Summary of Submissions:

The tables below summarise the comments received during the advertising period of the proposal, together with the Applicant's response to each comment.

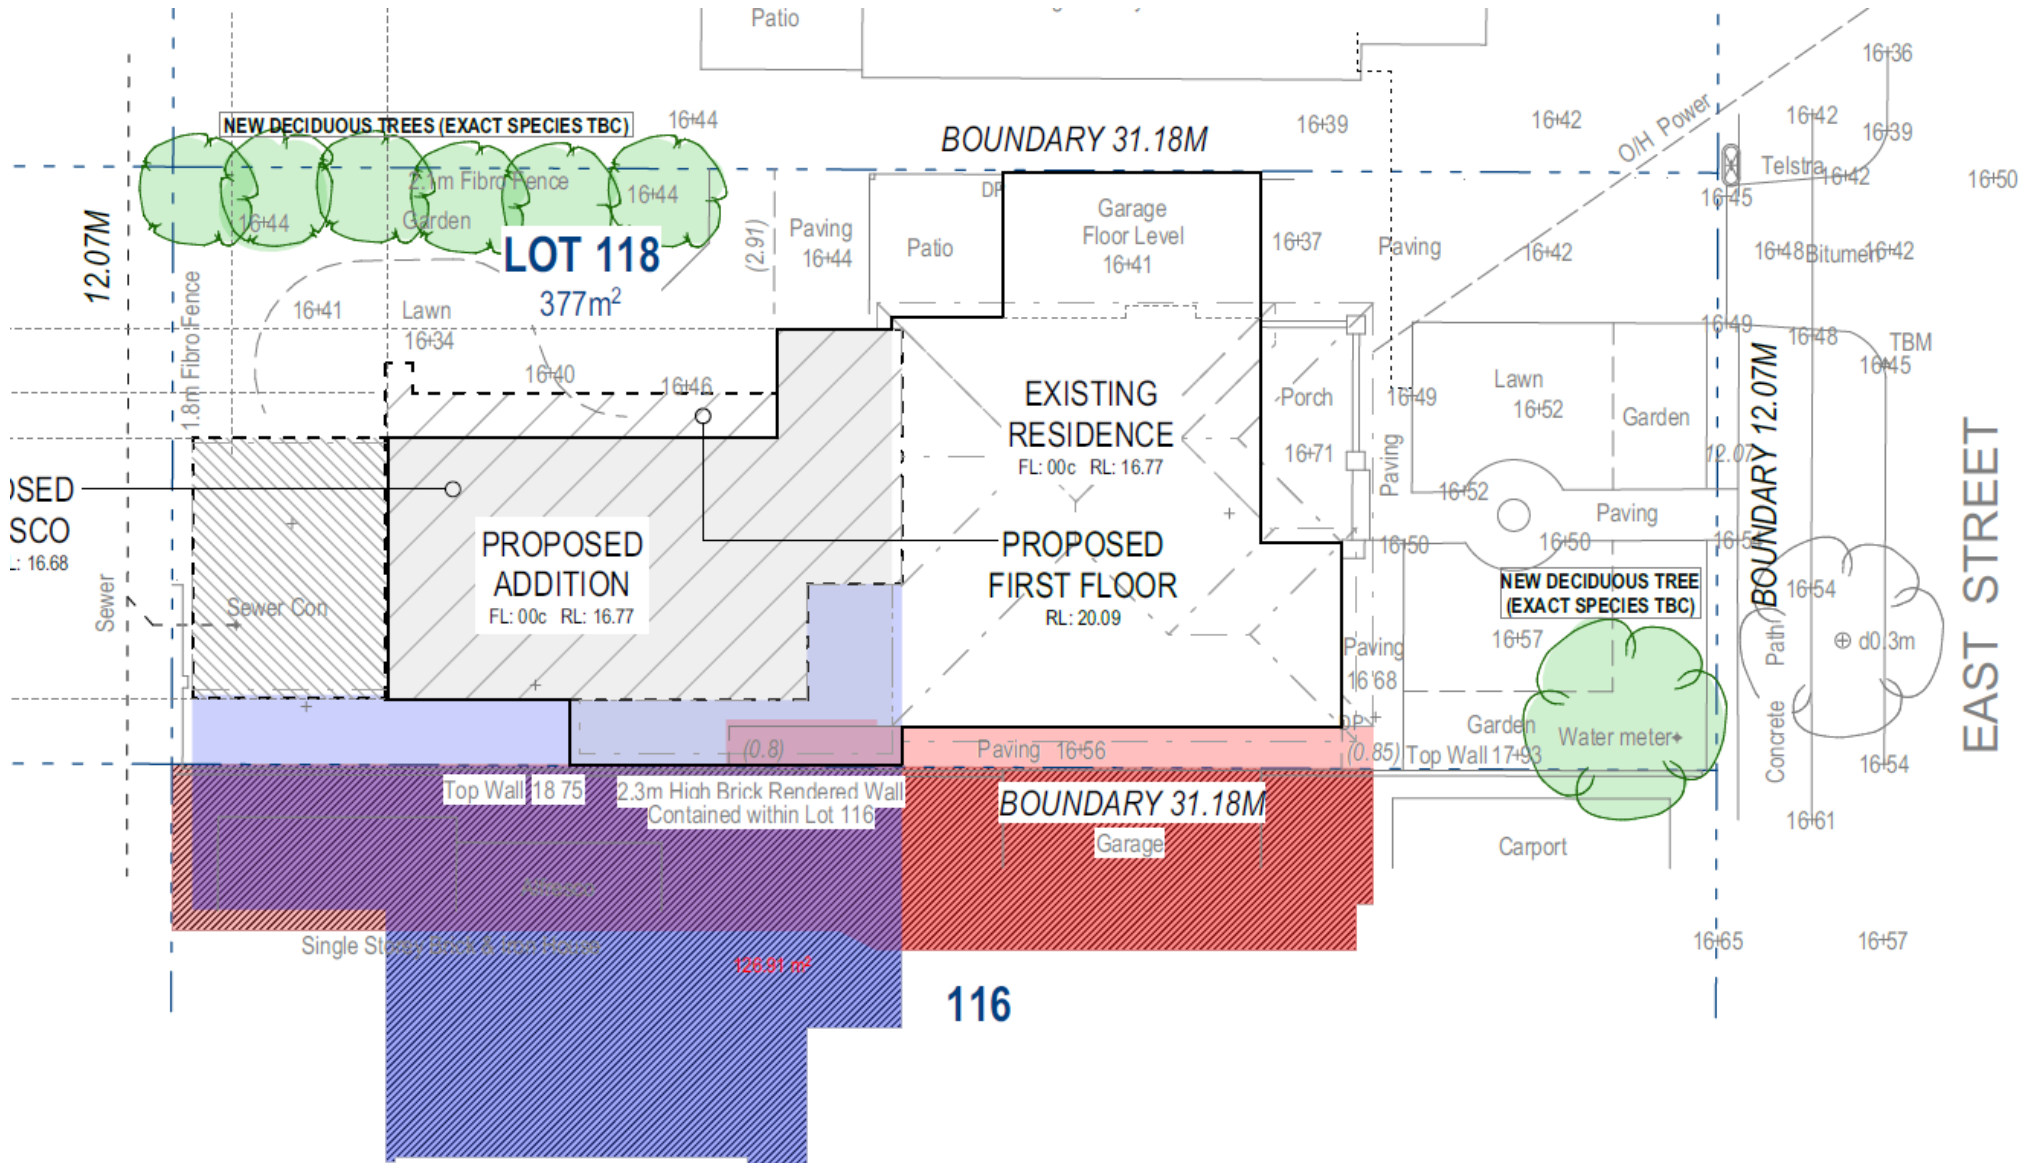
| Comments Received in Objection: | Applicant Comment: |
|--|--|
| <p><u>Overshadowing</u></p> <ul style="list-style-type: none"> • Concerns relating to overshadowing from boundary walls and reduced setbacks • Shadowing to the southern property will significant impact natural northern light in winter months • Concerns relating to lawn and plant growth due to vast shadowing proposed • Shadowing to adjoining properties will increase damp and moss/mould build-up • Concerns relating to solar power generation due to shadowing. Results in ongoing power loss and financial burden. | <ul style="list-style-type: none"> - Boundary wall is already in place, wholly contained within adjoining lot and extent of existing overshadowing demonstrated on shadow diagram. - Again, no "reduced setback" proposed regarding the element of the proposal responsible for potential overshadowing. Upper floor has been moved further from the South boundary to ameliorate overshadowing. - Additional shadow cast by proposed addition falls mainly over roof of the dwelling on adjoining lot. - There is sufficient roof area on adjoining dwelling unaffected by proposed addition in terms of overshadowing. Also noted as per 18 January 2023 there are no solar panels on the roof of adjoining dwelling. "Ongoing power loss and financial burden" is purely speculative and conjectural. |

Site plan/shadow diagram. Orange shading indicates existing overshadowing, predominantly caused by 2.3m high brick rendered wall contained within Lot 116. Proposed overshadowing in blue shows it'll mostly overlap with existing shadow, or cast over the roof of adjoining dwelling on Lot 116.
